TDECQ Reference Receiver Main Tap Location

IEEE 802.3cd Task Force, Geneva, January 2018

TDECQ Measurement Results

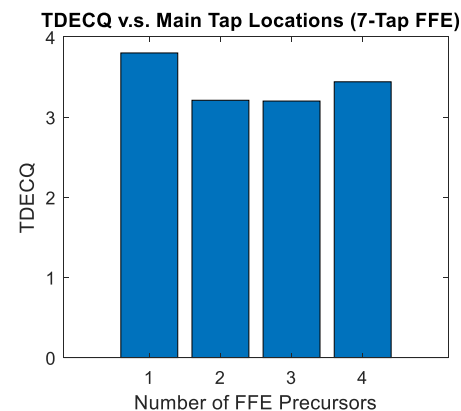
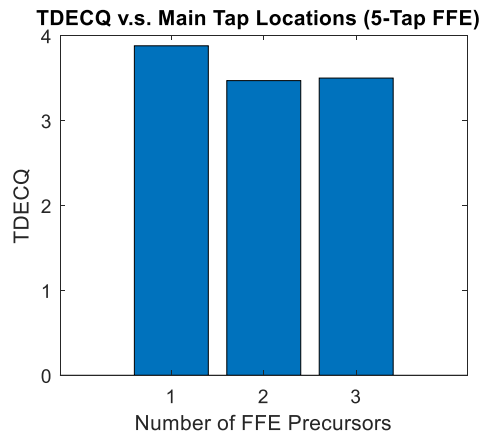
- We compared 100GBASE-DR TDECQ results for different number of FFE precursors.
- For 5-tap T-spaced FFE, FFE with two precursors give the best TDECQ results.
- TDECQ test completely fails if using 4 FFE pre-cursors because of no post-cursors!
- We tried 7-tap T-spaced FFE to have enough coverage for post-cursors and compare the impact of the number of precursors
- TDECQ values are almost the same for FFE with 2 or 3 pre-cursors. This means pre3 has no obvious impact on TDECQ result.
